ENGINE - LP COMPRESSOR - PROVIDE A NEW FAN CASE ASSEMBLY THAT ELIMINATES THE PROVISIONS
FOR A TRANSITION RING - CATEGORY CODE 7 - MOD.ENG-72-0160

V2500-ENG-72-0160

Before and after the alteration of the Fan Case Assembly
Fig.1

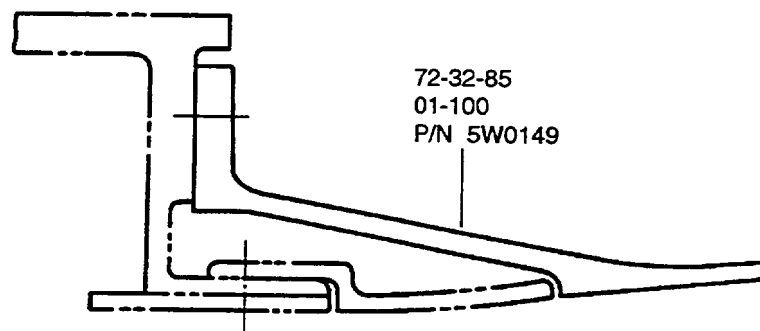
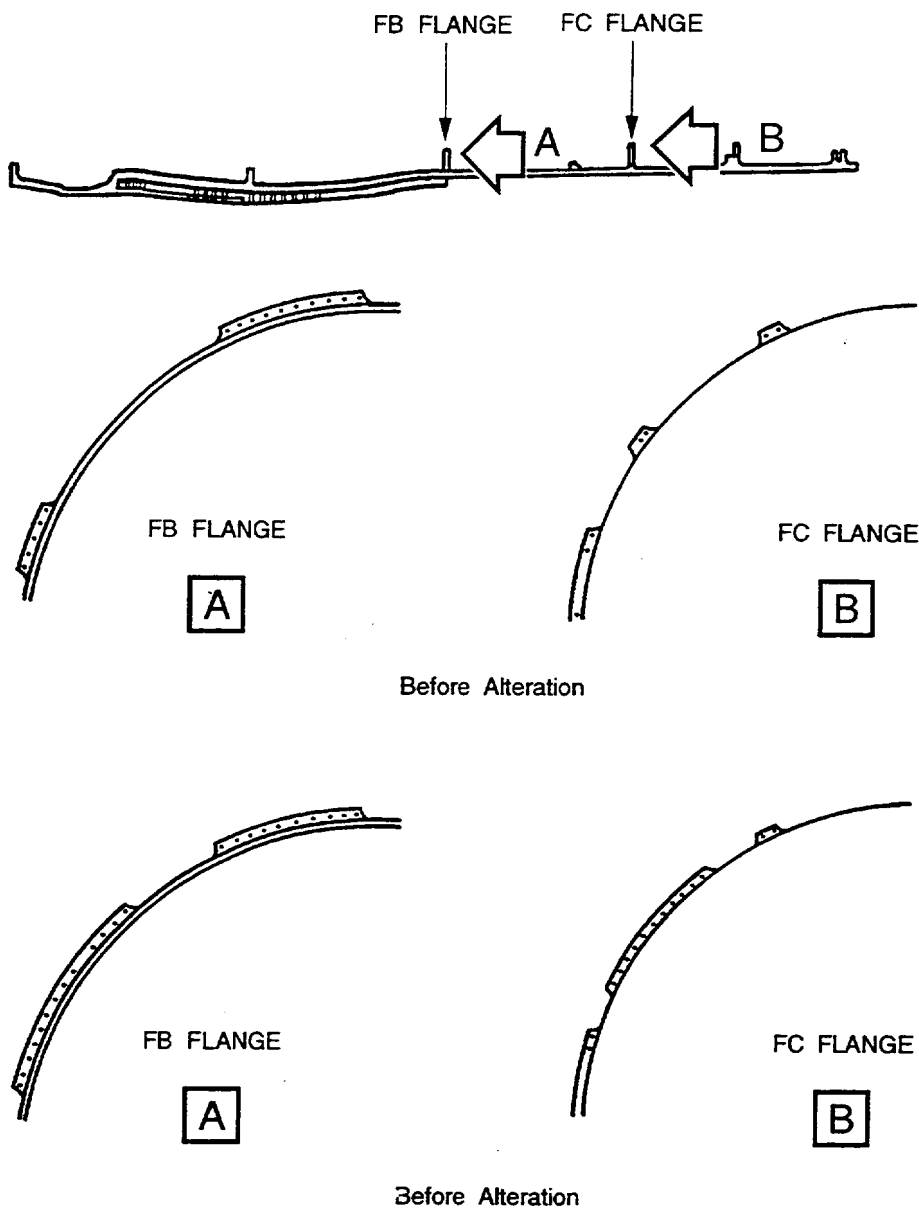
Current A5 Fan Case has the spigot feature at flexible ring for the purpose of supporting transition ring which was being axially compressed by intake rear end.

- (1) The spigot feature at front portion is eliminated. Refer to Figure 1.
- (2) Scallop s are changed and holes are added on FB and FC flanges in the Fan Case Assembly. Refer to Figure 2.
- (3) PMA Cooling Air Tubes are rerouted to the new Intermediate Case Module. Refer to Figures 3 and 4.
- (4) The module part number of the Intermediate Case was changed from 5W0130 to 5W0150.

Install the bracket at the flange FC
Fig.5

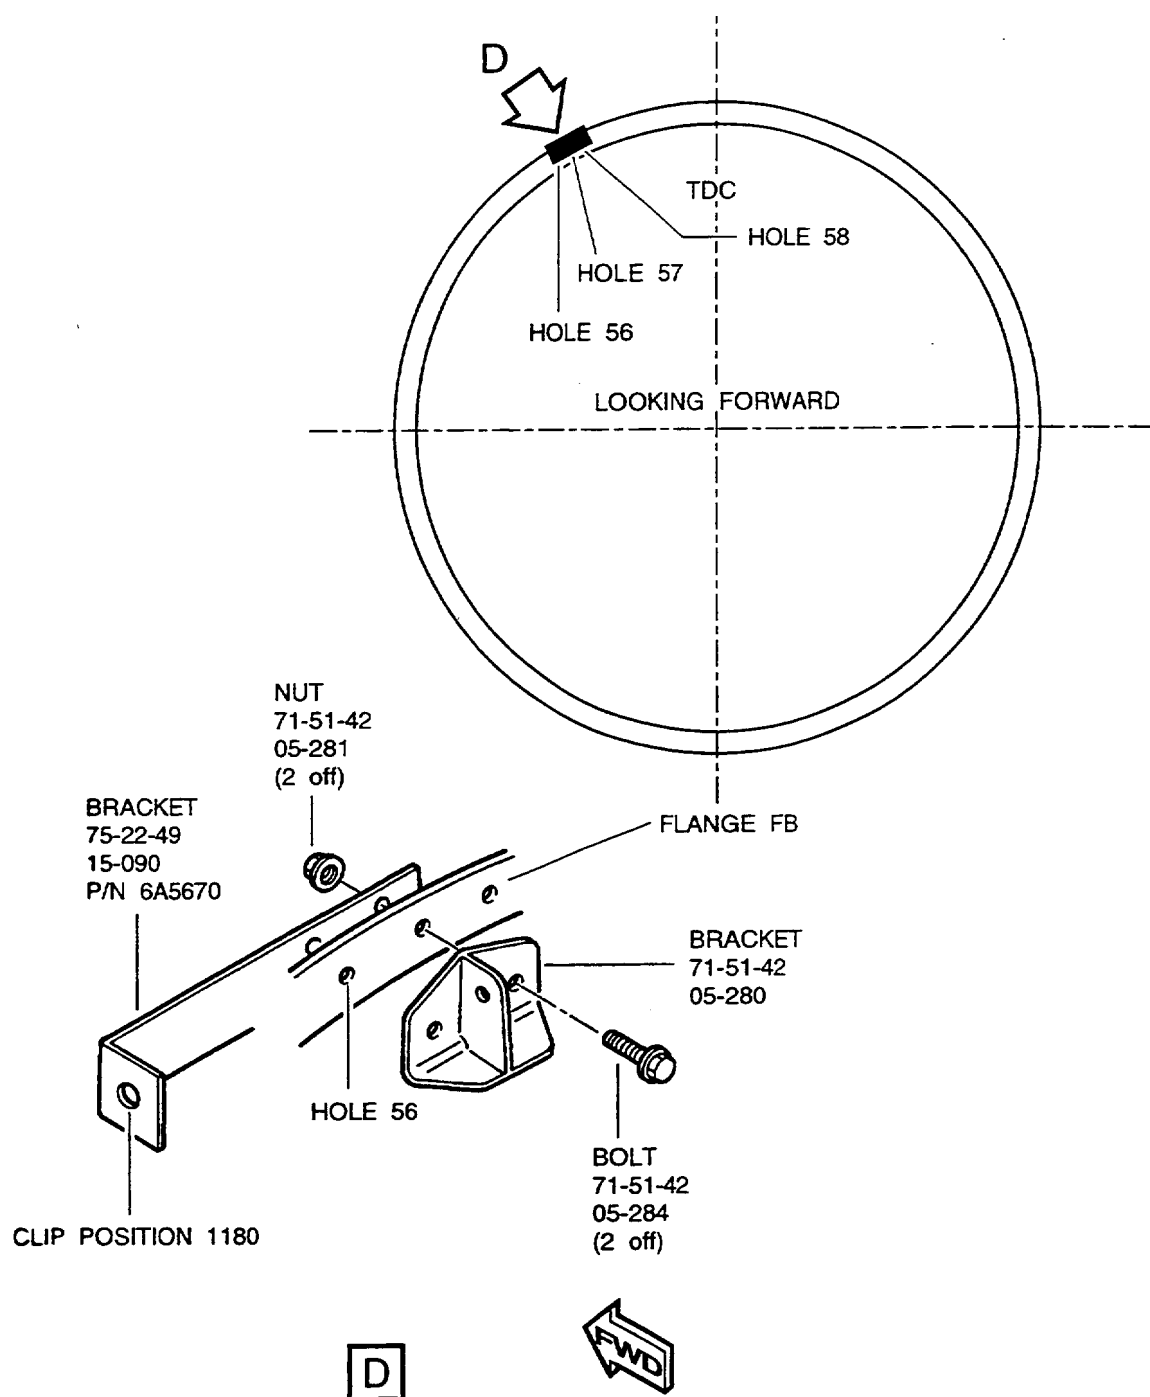
- (a) Install the bracket (75-22-49, 15-085, P/N 6A5669) with bracket (71-51-42, 05-830) at the holes 50 and 51 of flange FC with the two bolts and two nuts as figure 5 on Detail C. TORQUE the nuts to between 85 and 105 lbfin (10 and 12 Nm). Refer to 1.L. (3), TASK 70-41-00-400-501.

Install the bracket at the flange FB
Fig.6

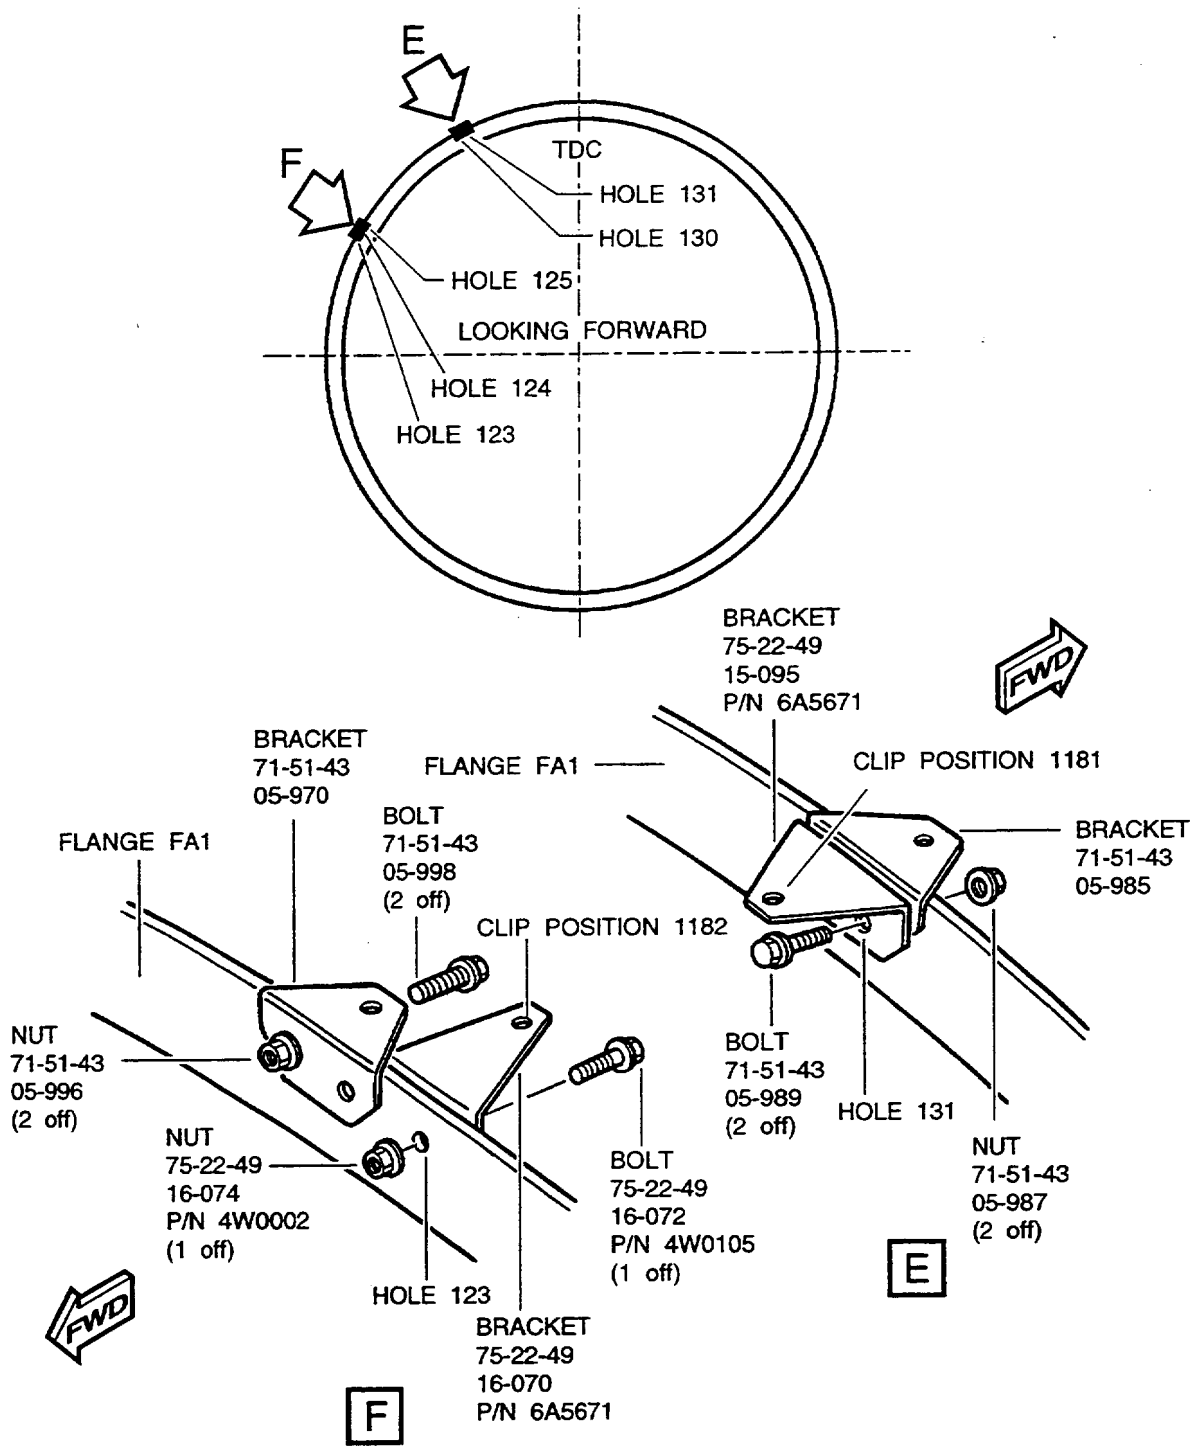
- (b) Install the bracket (75-22-49, 15-090, P/N 6A5670) with bracket (71-51-42, 05-280) at the holes 56 and 57 of flange FC with the two bolts and two nuts as figure 6 on Detail D. TORQUE the nuts to between 85 and 105 lbfin (10 and 12 Nm). Refer to 1.L. (3), TASK 70-41-00-400-501.

Install the bracket at the flange FA1
Fig.7

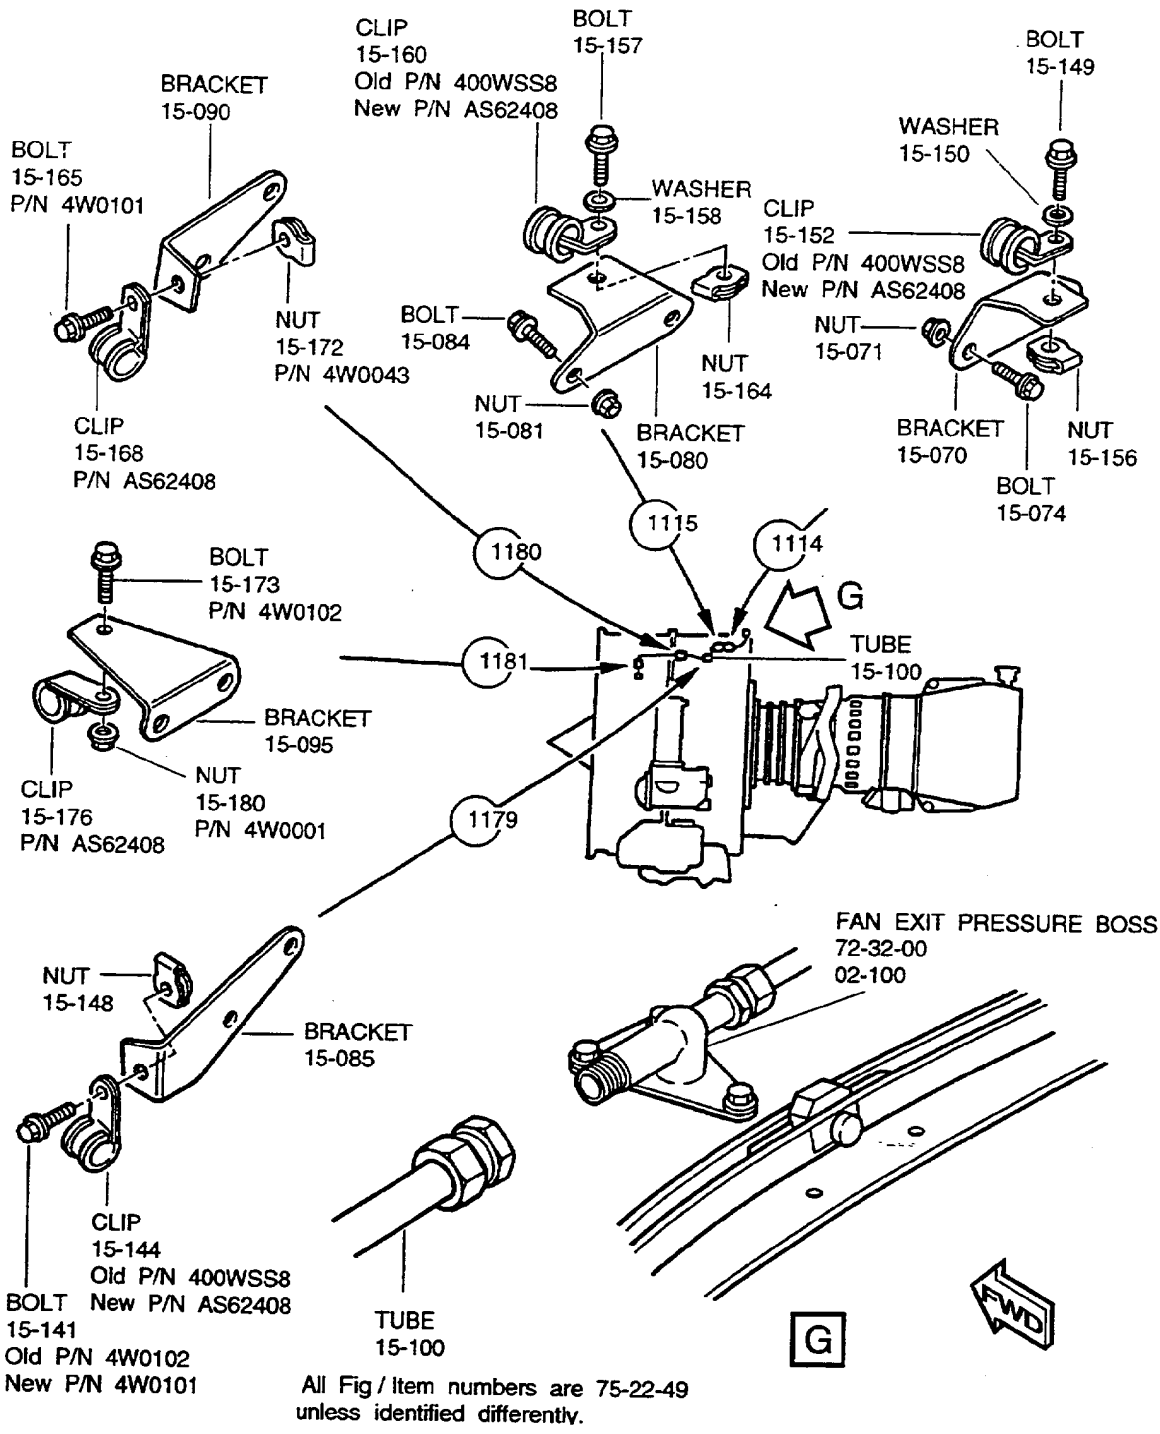
- (c) Install the bracket (75-22-49, 15-095, P/N 6A5671) with bracket (71-51-43, 05-985) at the holes 130 and 131 of flange FC with the two bolts and two nuts as figure 7 on Detail E. TORQUE the nuts to between 85 and 105 lbfin (10 and 12 Nm). Refer to 1.L. (3), TASK 70-41-00-400-501.

- (d) Install the bracket (75-22-49, 16-070, P/N 6A5671) with bracket (71-51-43, 05-970) at the holes 123 and 125 of flange FC with the three bolts and three nuts as figure 7 on Detail F. TORQUE the nuts to between 85 and 105 lbfin (10 and 12 Nm). Refer to 1.L. (3), TASK 70-41-00-400-501.

Reidentification of the new module identification plate
Fig.11

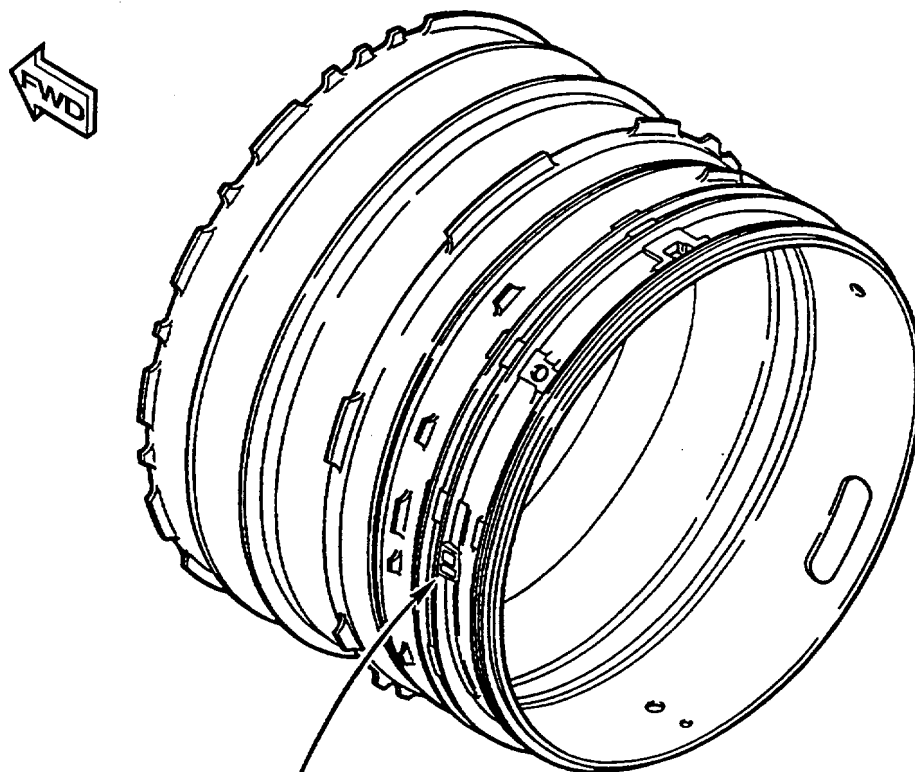
- (4) Replace the Module Identification Plate in accordance with following procedures See Figure 11

(a) Find the existing 5A2189, module identification plate on the LP Compressor/Intermediate Module and make sure that module assembly number is 5W0130.

(b) Remove the two bolts and existing module identification plate.

(c) Discard the existing module identification plate.

(d) Make a mark of the new module assembly part number 5W0150, and existing serial number to the new 5A2189, module identification plate.
